Tipple Residence, Kaiteriteri

Geotechnical and Structural Deck Commentary

Client: Tipple Family
Supplied to: Tasman District Council
From: GM Designs Consulting Engineers Ltd
CPEng Representative: Graeme McMillan (47102)
Reference Number: P7890
Date of Issue: 4th November 2024

Brief: 38 Kaiteriteri Sandy Bay Road, Kaiteriteri – New Deck Commentary

Figure 1. - Site Overlay with September Sampling Hole (SH) & Geoconsult Hand Auger (HA) test locations.

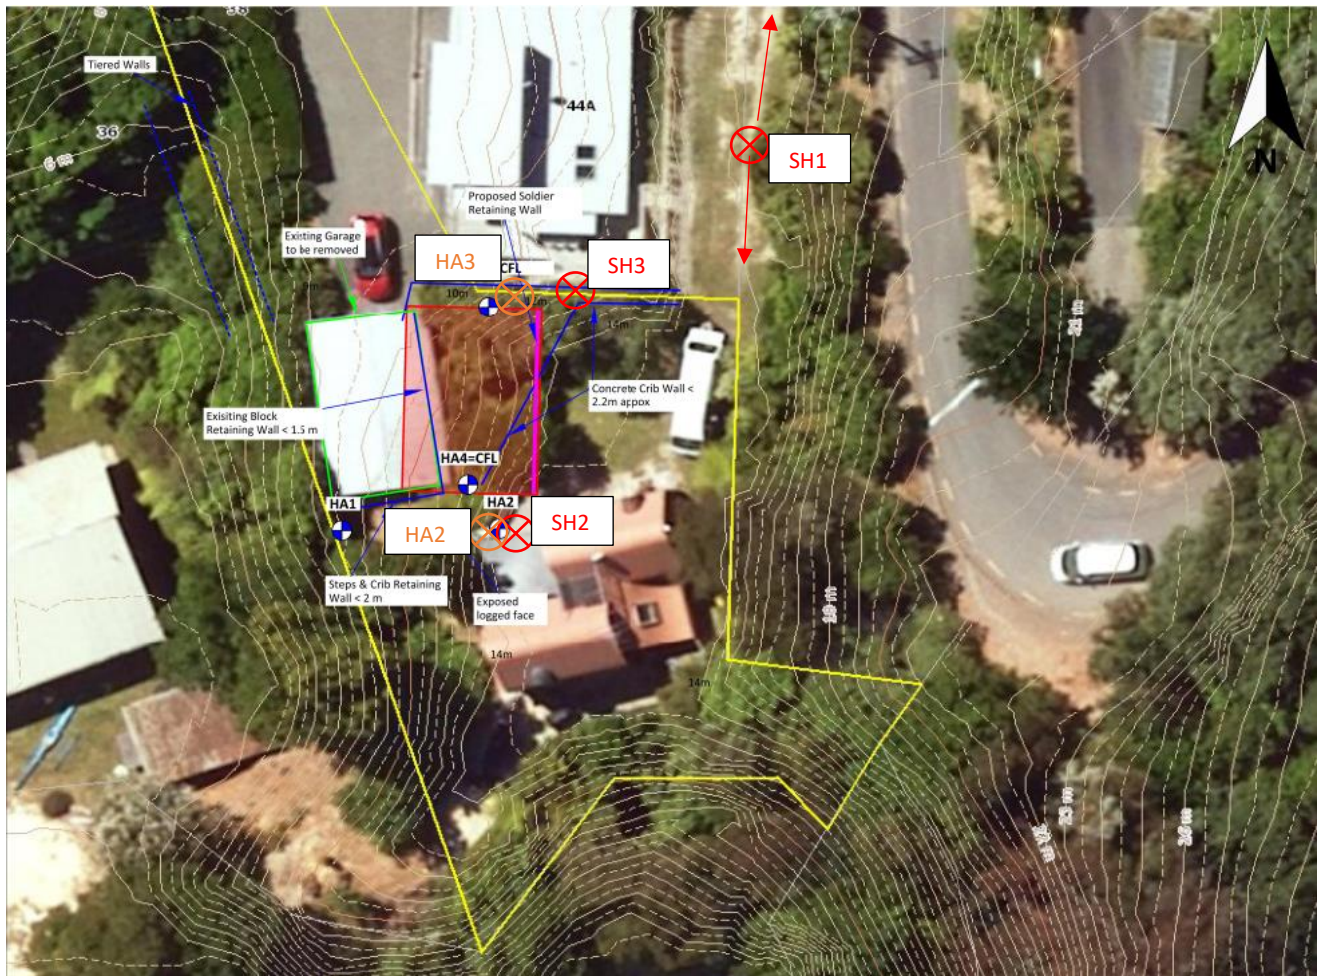
Figure 1 shows a site plan that overlays the September sampling holes with the location of hand auger investigations completed by GeoConsult.

The testing completed with GM Designs on-site included the sampling holes (SH) encountered the same soil types in the same areas as the Geoconsult testing report hand augers (HA) indicate. Comparatively, the GeoConsult testing extended to a depth of 4m at HA2, whereas the 150mm auger achieved a depth of 2.1m. HA2 indicates that below 1.6m, a consistent layer of very stiff silty clay was encountered that continued until the test's end.

SH2 By GDm Versus GA2 by Geoconsult are the most applicable sampling results due to their proximity to the deck. The results of these tests are intended to represent best the soils encountered by the deck foundation. Additional site images are included in Appendix A.

Figure 2a & 2b. - Yellow clay layer samples from SH3 V HA3

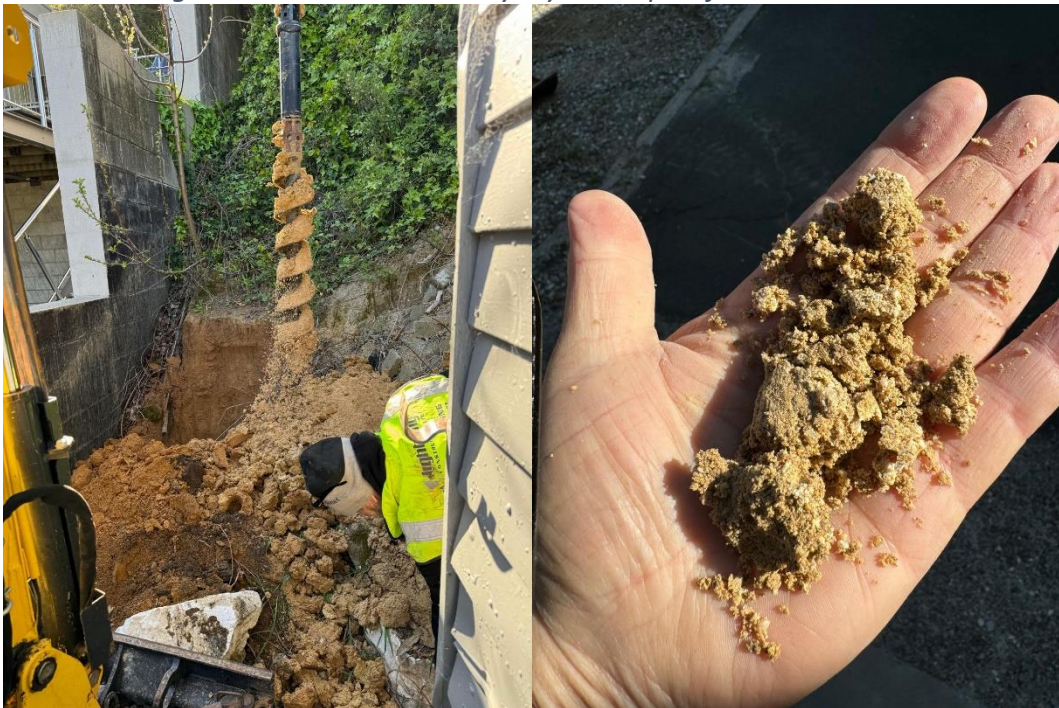
- 1.1 First Sampling Hole – **SH3** Bores undertaken by GDM referenced by **HA3** Geoconsult in 2021 report. The soil bank below the house, which had been cut during the house construction some years ago, revealed layers of yellow clay. As the depth increased, the clay became drier and lighter in colour, with minor quartz grit present. At 1.3 m, the soil was dense and moisture-free.

Figure 7a. - Deep Post Section

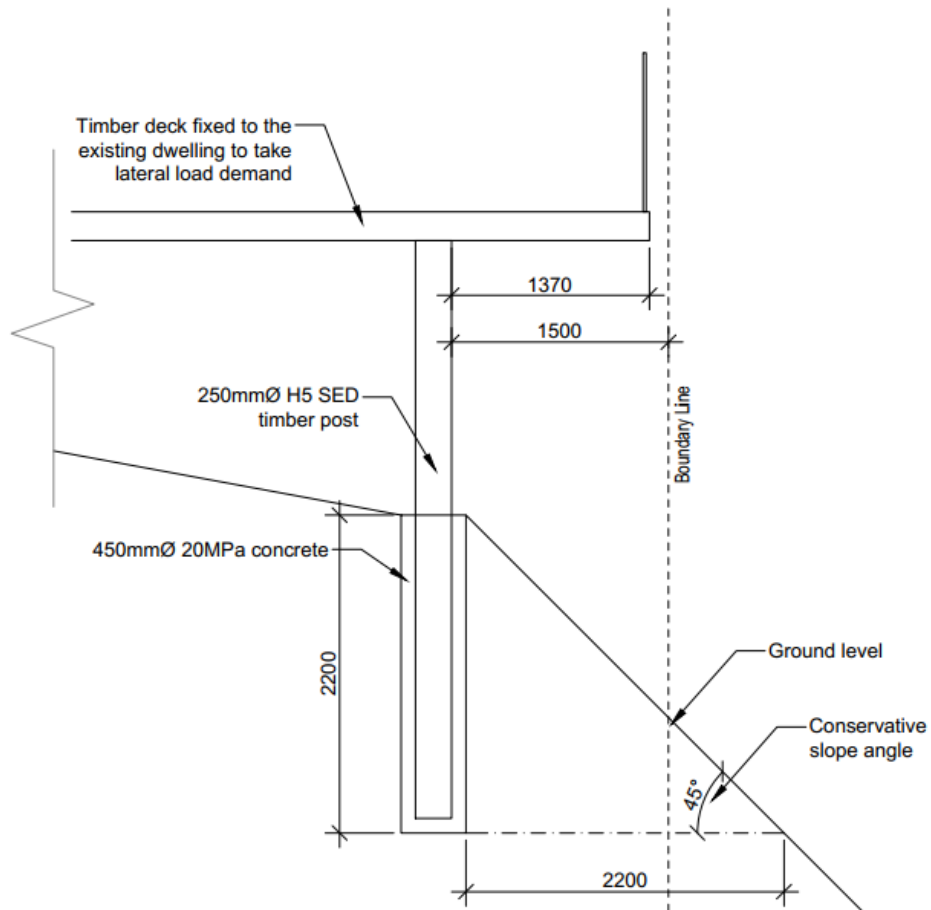
The deck loads include 1.5 kPa live load (Q) and 0.25 kPa dead load (G) providing a working load of $G + Q = 1.75$ kPa. The loaded area for one of the 250mm diameter SED H5 piles located on the edge of the deck is $1.90 \text{ m} \times 1.37 \text{ m} = 2.60 \text{ m}^2$. This results in a total axial load demand of 4.6 kN. With a 450 mm diameter base for the footing, the demand on the soil is 29 kPa.

The safe allowable bearing pressure of the sandstone clay at a minimum depth of 2.0m indicated 300 kPa. Compared to the bearing demand from the post, this provides a factor of safety of 10.4 times, hence, this doesn't impose added risk to the lower neighbours.

A schematic of the large post section has been formed to illustrate the design in Figure 7a.

Figure G1. – Post to ground interface that highlights the top of the concrete partially hidden by topsoil used in the soil loading calculations. Additionally, the image shows the importance of placing waterproof membrane around the base of the pile to protection from weathering and erosion.

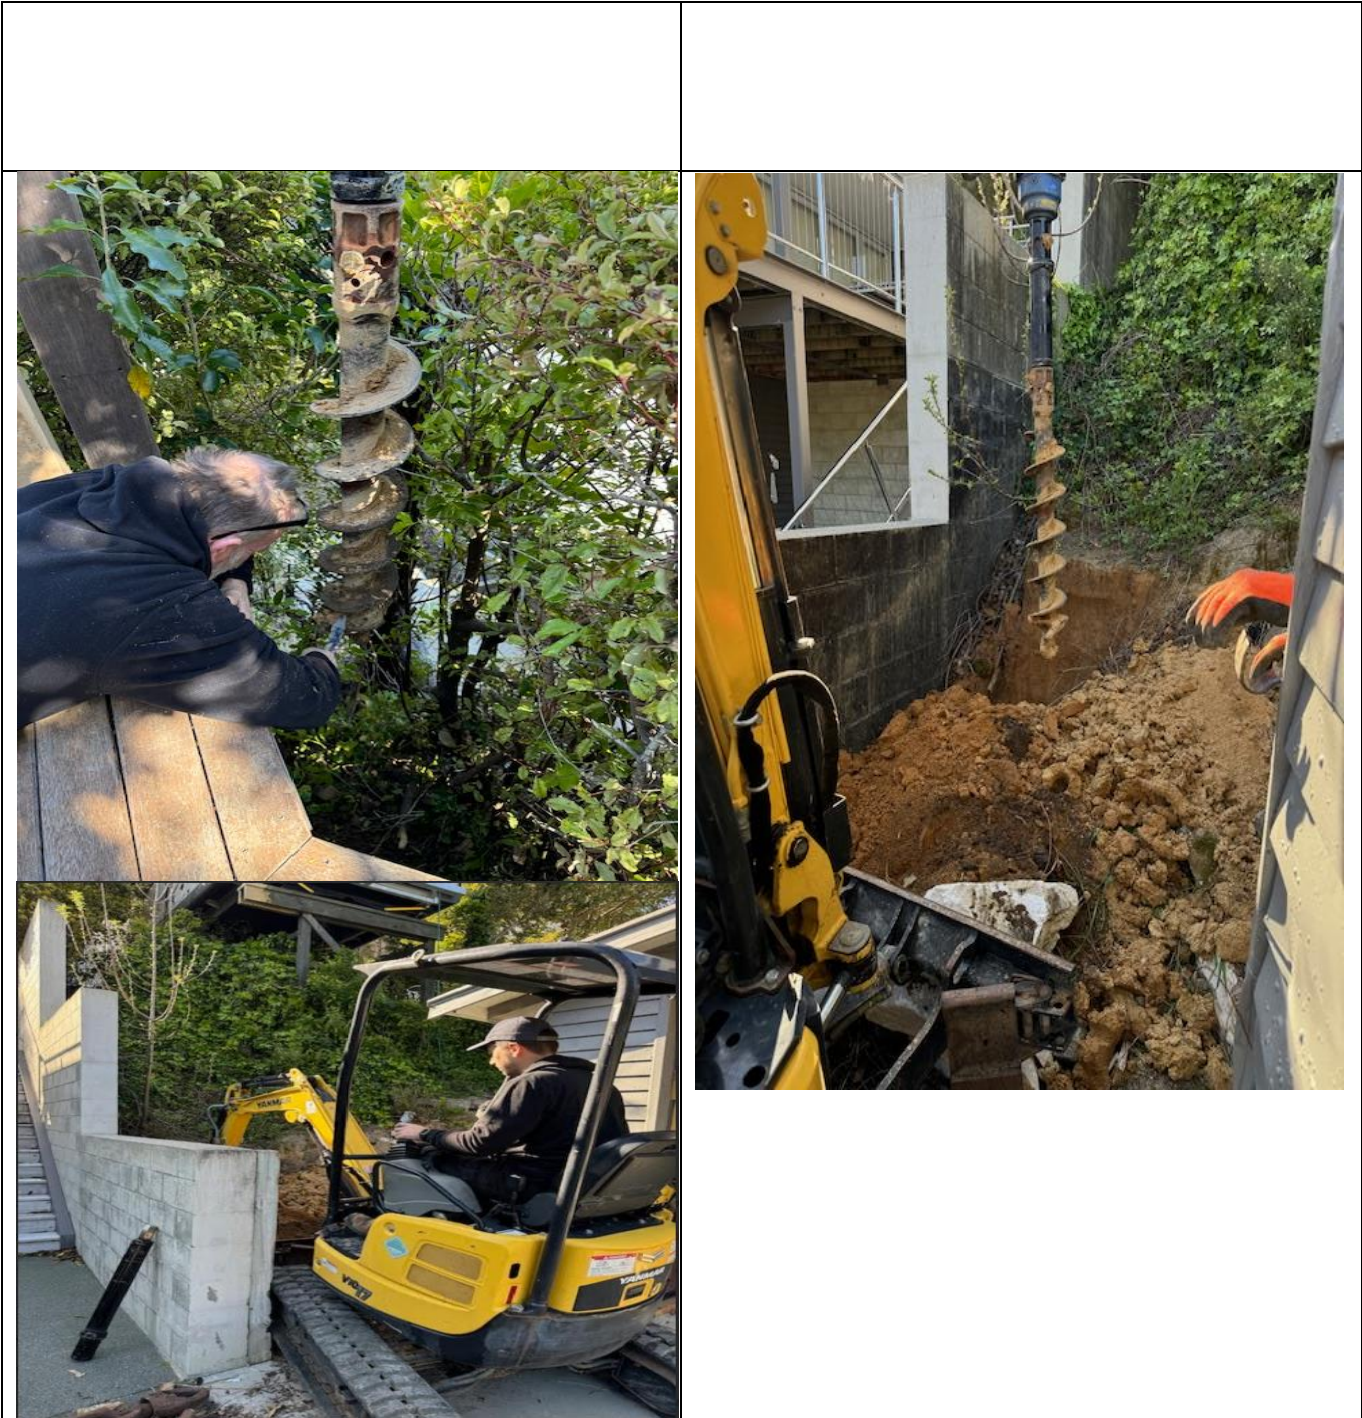
Deck Images: F 1-6 above depict the required overlays to secure the erosion-free weathering properties of the upper crust directly under the upper decking. The cracks below are undesirable, and need fixing to prevent further issues and ensure this mechanism for the long-term plan on this site achieves overall acceptability. We conclude a protective cover over the upper crust is required.

The above feature is where the original erosion, caused by the flow of water runoff, has caused this undesirable breakdown of the upper crust of the graduated topsoil and lower weathered sandstone. This needs fixing with the tampering by using clay to fill up all void holes. These veins or cracks in the upper crust shall then be overlaid with well-formed flow dish channels, say 150mm wide and graduated depth, so that the water from the house under the deck to the outside and down the bank away from any infrastructure to the natural water channels double-lined with Agtuf 150 micron film as the approved DPM medium.

To prevent erosion. A damp-proof membrane (DPM) of at least 150 microns should be applied around the base of all critical piles. This membrane should extend from the house edge and around the posts to prevent water migration and soil erosion.
